VIRGINIA ELECTRIC AND POWER COMPANY
RICHMOND, VIRGINIA 23261

January 26, 1993

VIRGINIA ELECTRIC AND POWER COMPANY
SURRY POWER STATION UNITS 1 AND 2
SECOND TEN YEAR INSERVICE INSPECTION INTERVAL
RELIEF REQUESTS

**Surry Units 1 and 2
ISI Relief Requests**

| INSERVICE INSPECTION DETAIL DRAWING OUTSIDE RECIRC SPRAY PUMP; 2-RS-P-2A SURRY POWER STATION UNIT 2 VIRGINIA POWER | | | |

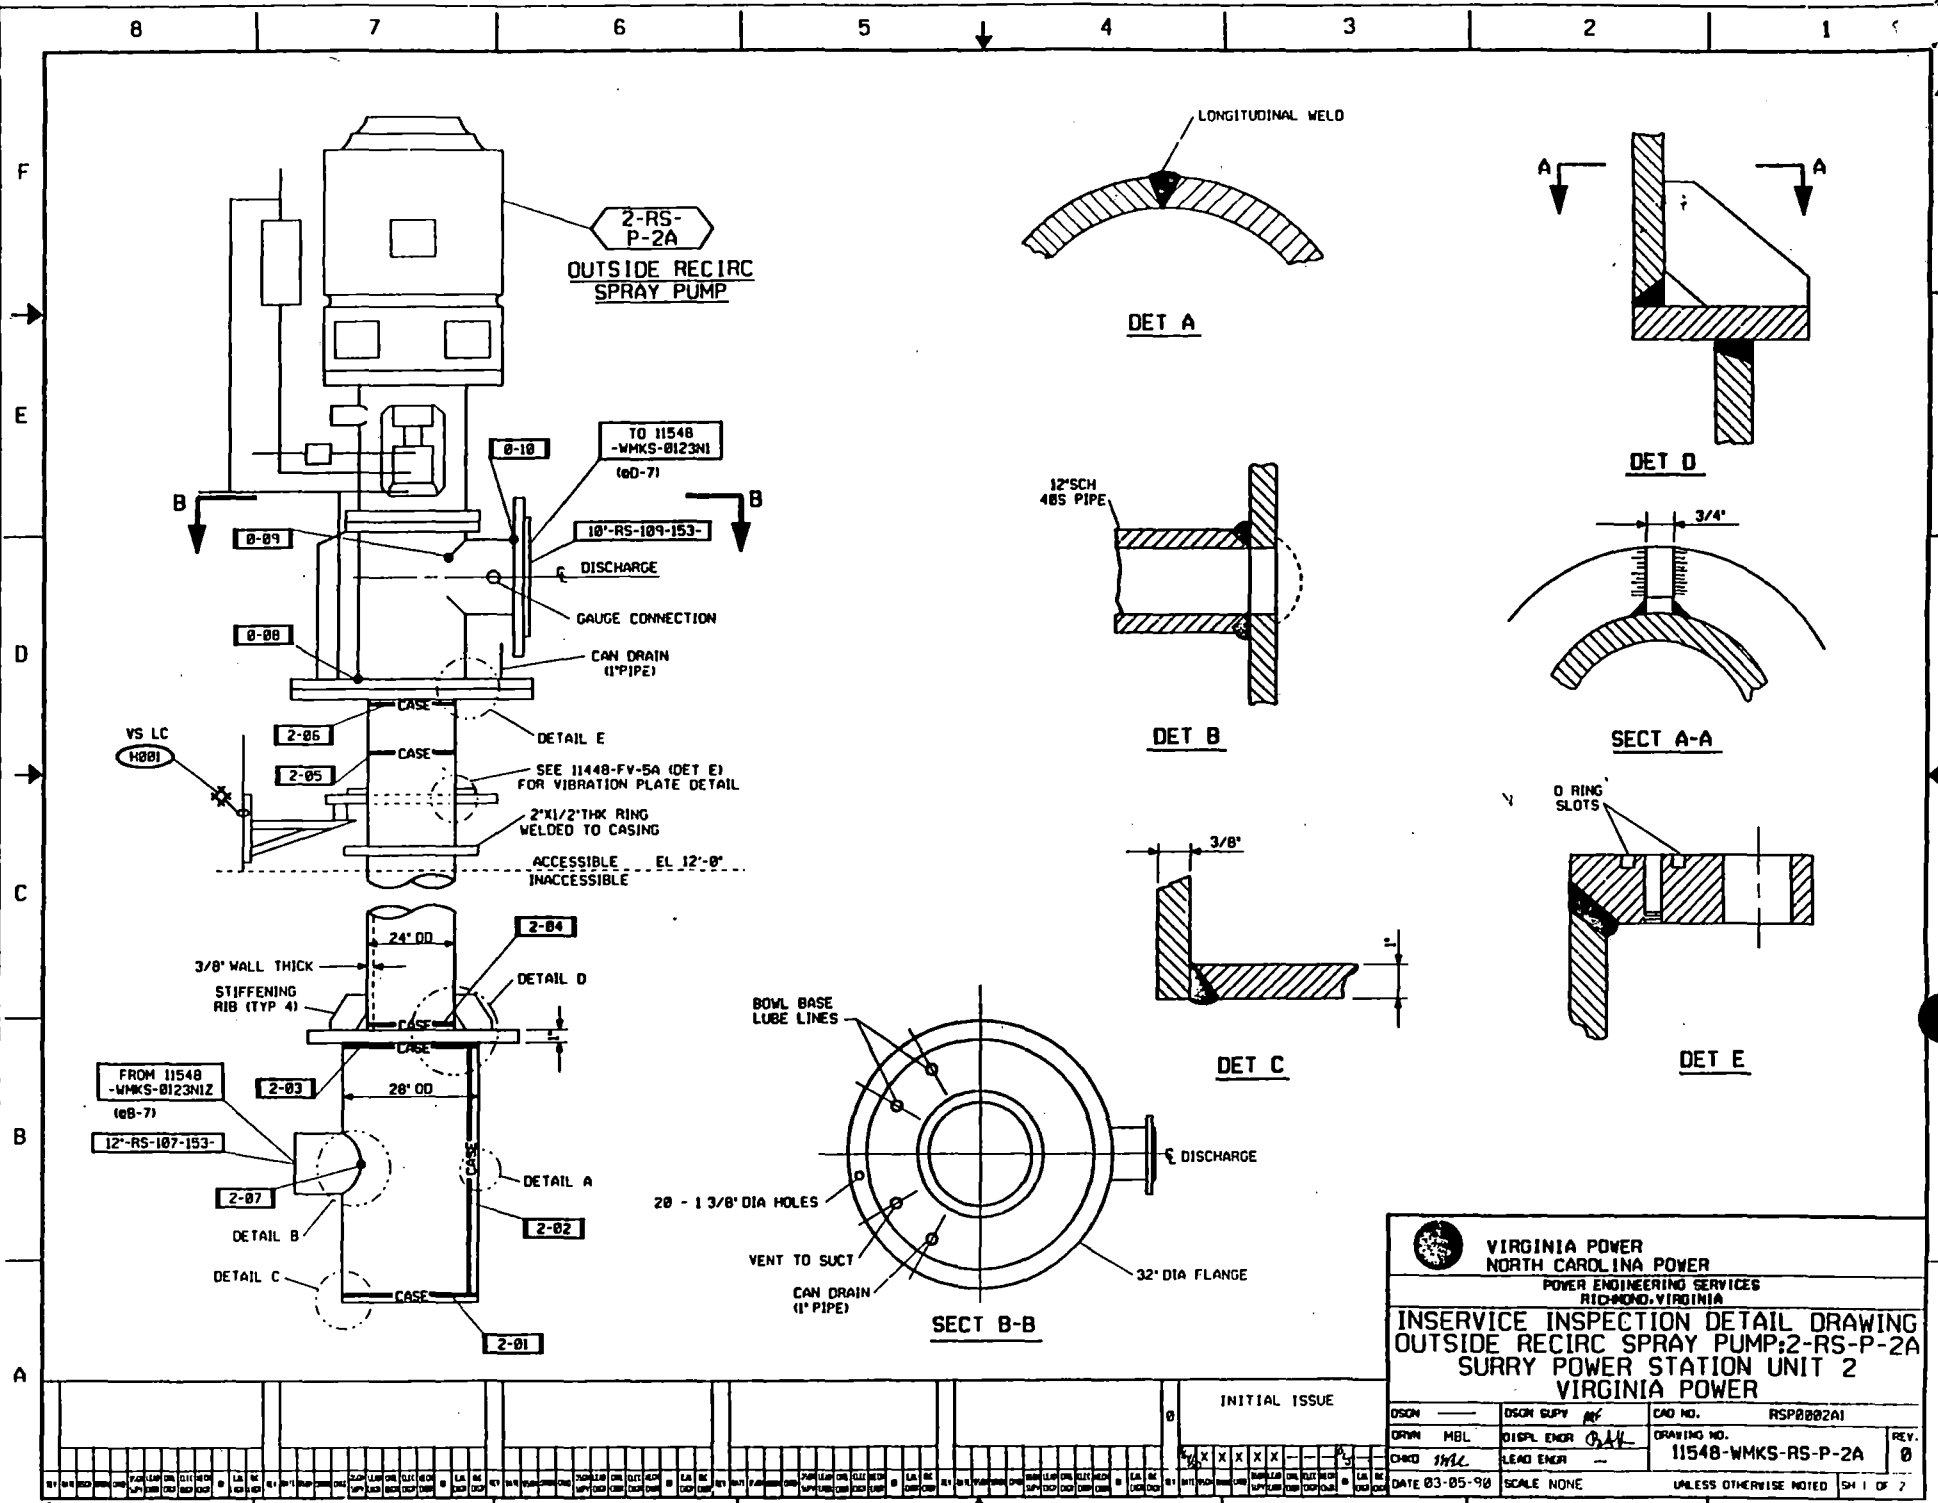
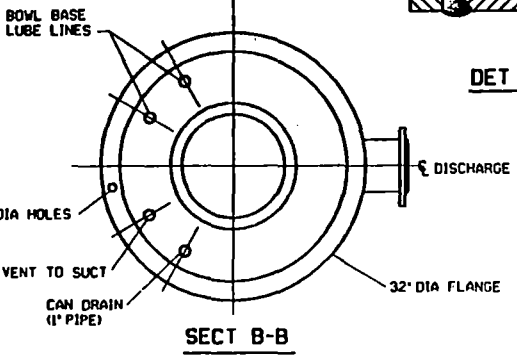
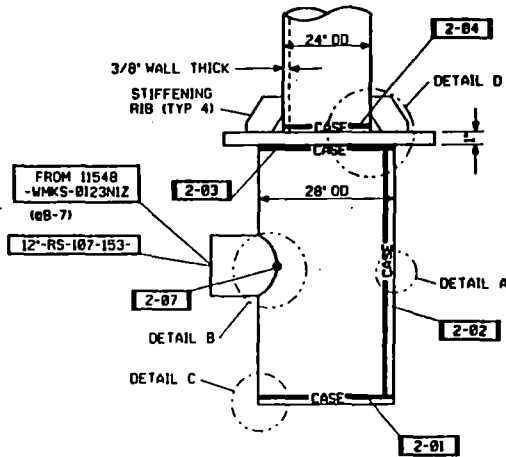
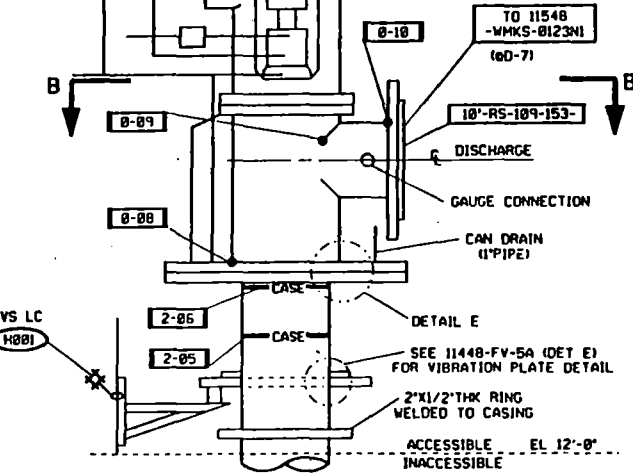
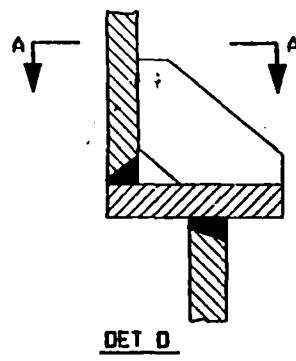
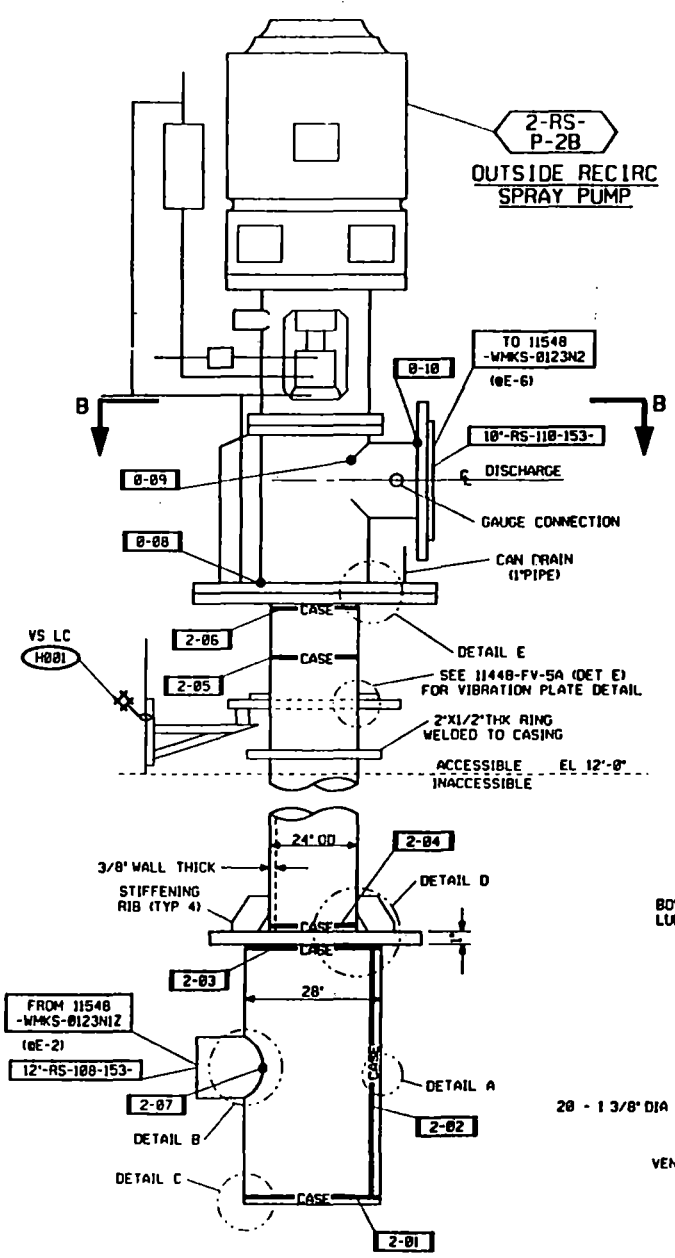
Category C-G, Item C6.10, Pump Casing Welds, requires that a surface examination be performed on 100% of the welds each interval. The examination can be limited to one pump in the case of multiple pumps of similar design, size, function, and service in a system.

A remote visual examination (VT-1) of the accessible portions of the I.D. of the pump casing welds will be performed only if the pump is disassembled and the pump shaft removed for maintenance.

**ISI CLASSIFICATION BOUNDARY DRAWING
 FEEDWATER SYSTEM
 SURRY POWER STATION UNIT 2
 VIRGINIA POWER**

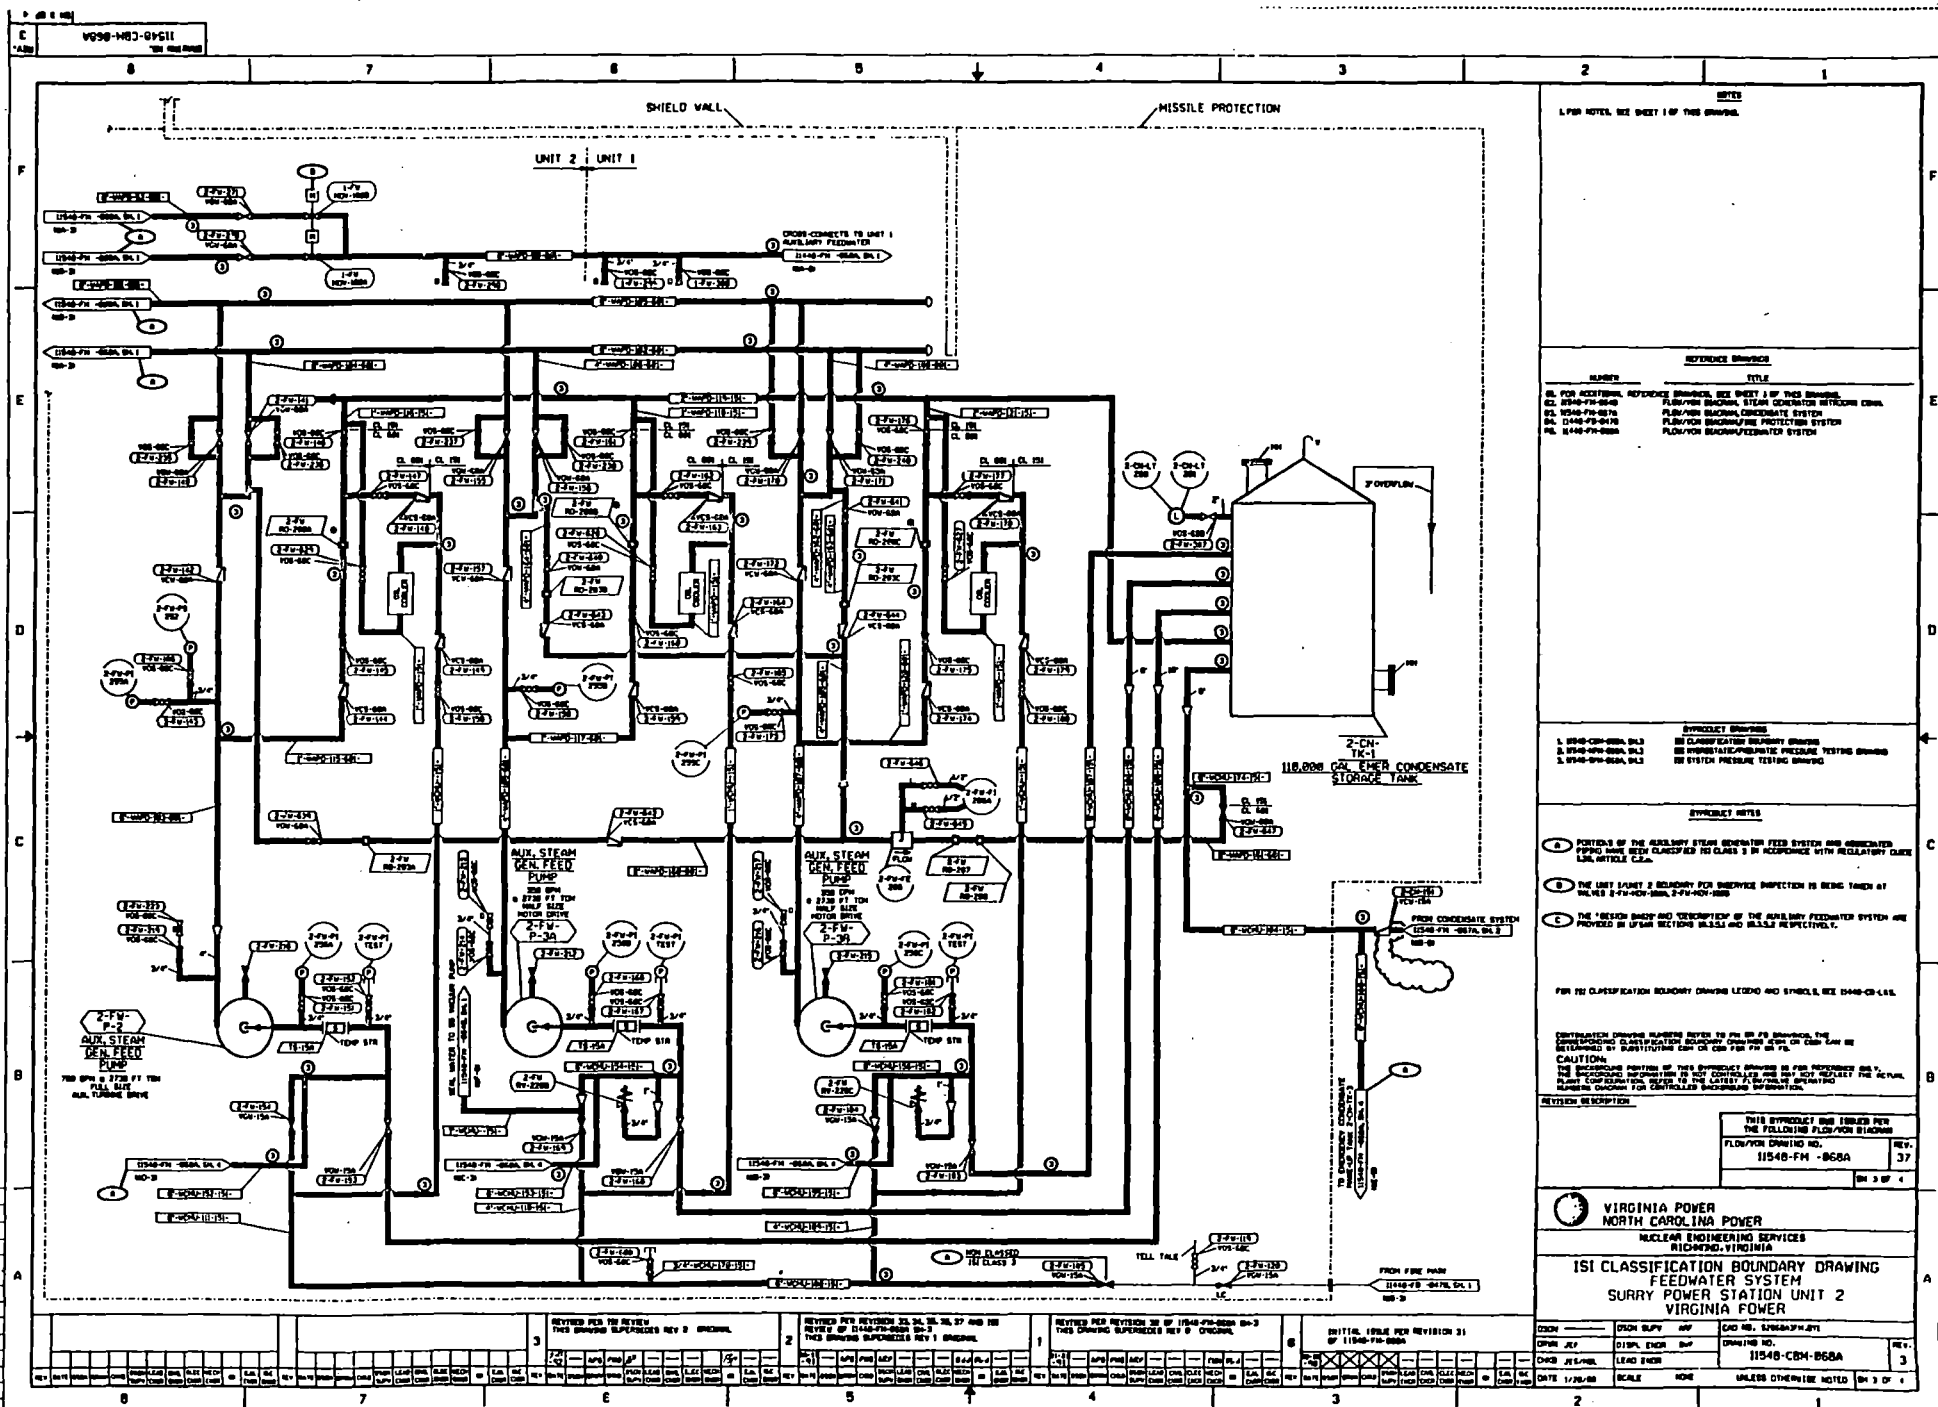
ISI Class 3 System Hydrostatic Test required in IWD-5223 of ASME Section XI, where design pressure is 1432 psig and the resultant test pressure is 1576 psig.

Three pressure reducing orifices 2-FW-RO-200A, 2-FW-RO-200B, and 2-FW-RO-200C provide during normal operation a pressure drop from approximately 1200 psig to 110 psig. The system design takes advantage of this pressure drop by incorporating lower pressure rated piping downstream of the orifices. However the higher pressure rated piping continues beyond the orifices for some distance. The actual pipe design pressure class change occurs at downstream check valves 2-FW-148, 2-FW-163, and 2-FW-178 and manual valves, 2-FW-146, 2-FW-161, and 2-FW-176. The check valve operation, however, does not allow separation of the lower pressure class system, when testing the higher class piping in accordance with IWD-5223. IWD-5223 would require a test pressure of 1576 psig on the higher pressure class components in question. The downstream connecting piping has a design pressure of 150 psig and a corresponding test pressure of only 165 psig. As such, the connecting components would be overpressurized during the required Section XI test. The test boundary could be backed up to manual isolation valves 2-FW-147, 2-FW-162, and 2-FW-177, however hydrostatically testing this test boundary would also pressurize the auxiliary feedwater pumps and their suction connection. These pumps have welded discharge connections and cannot be isolated from the test boundary due to the absence of a drain or vent valve in the area

ISI CLASSIFICATION BOUNDARY DRAWING
 MAIN STEAM SYSTEM
 SURRY POWER STATION UNIT 2
 VIRGINIA POWER

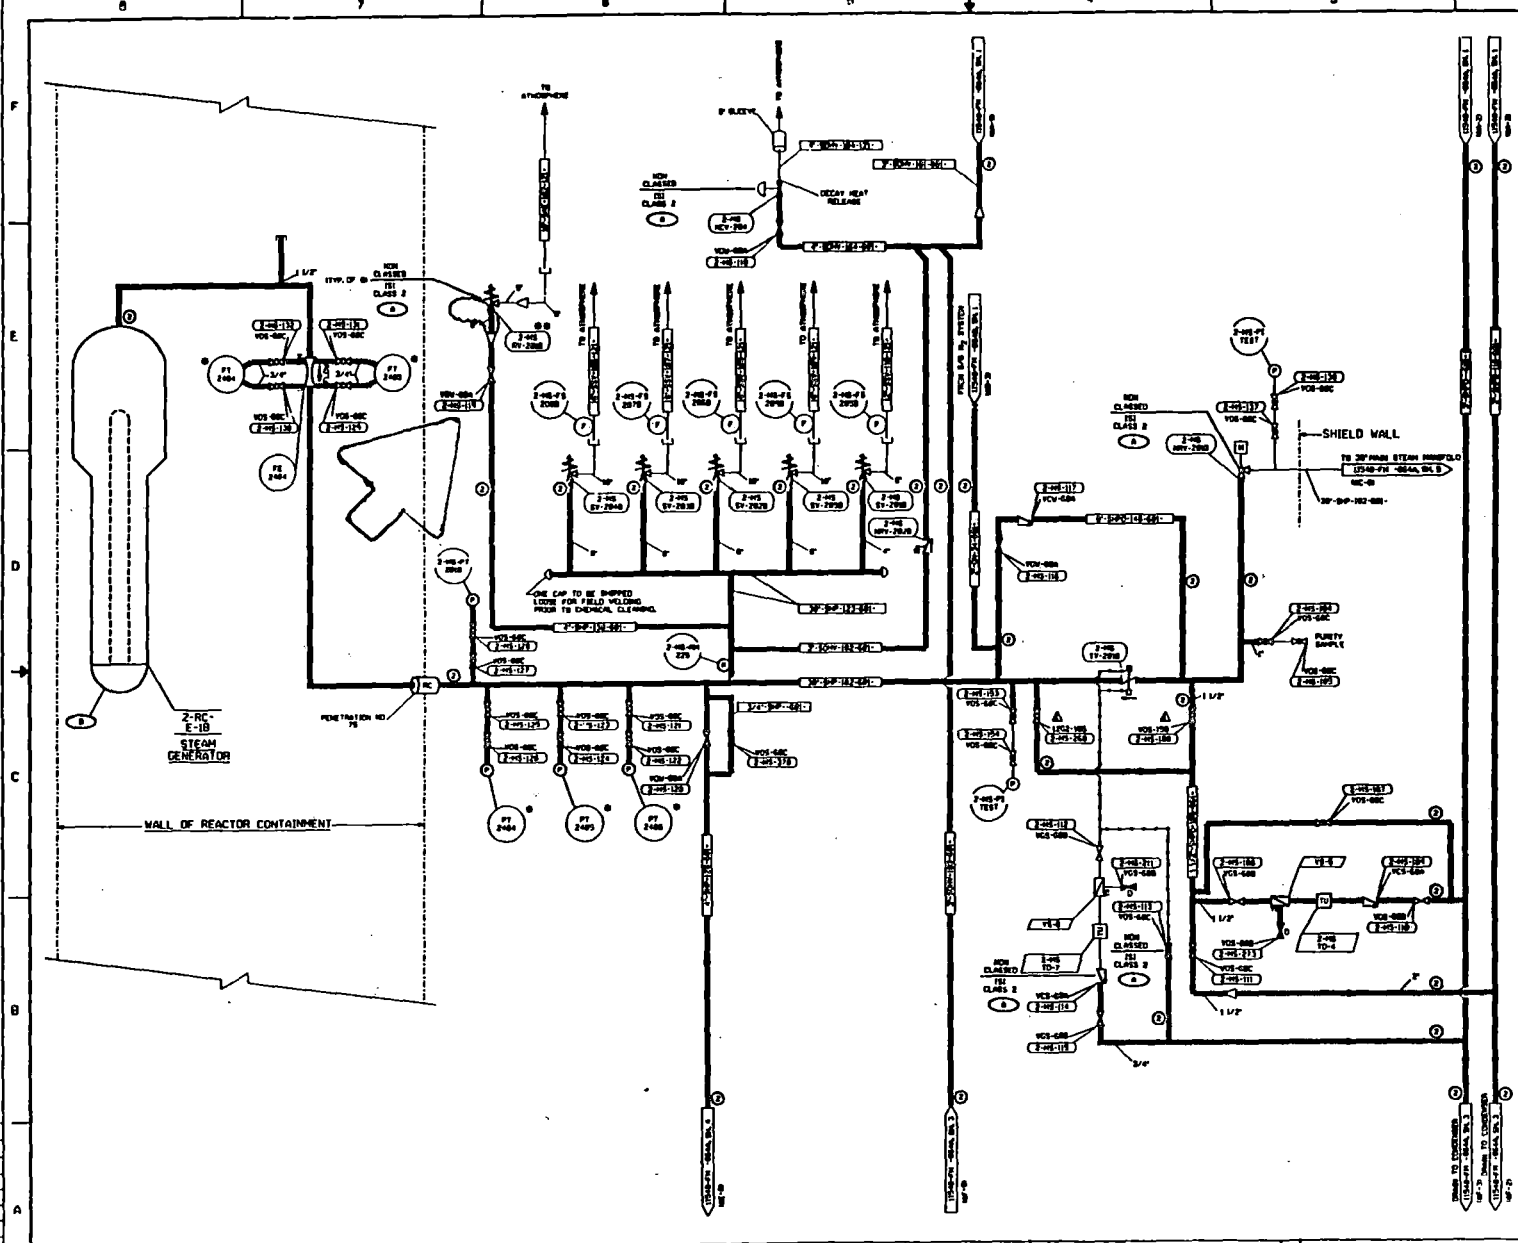
When Code Case N-416 was incorporated into Regulatory guide 1.147, "Inservice Inspection Code Case Acceptability-ASME Section XI Division 1, relief requests were no longer needed, since the hydrostatic test was deferred to the end of the interval hydrostatic test described in table IWC-2500-1. This appeared to be the minimum hydrostatic testing that could be achieved for the steam generators. Recently in Revision 9 of Regulatory Guide 1.147, you approved Code Case N-498, Alternative Rules for 10-Year Hydrostatic Pressure Testing for Class 1 and 2 Systems Section XI, Division 1. This Code Case allows testing of the class 2 steam generators at nominal operating pressure. As a result, no hydrostatic test is now required by ASME Section XI on these components under normal circumstances, when incorporating Code Case N-498. The hydrostatic test of Code Case N-416 is still required to be performed, however. As described before, the component identified above can only be hydrostatically tested by additionally testing the connecting steam generator. Requiring a full steam generator test only for this replacement activity is considered impractical, due to the difficulties of the test described previously.

The alternative requirements described in Code Case N-416, a volumetric examination of the full penetration welds and a visual examination (VT-2) at nominal operating pressure was previously performed and deemed acceptable.
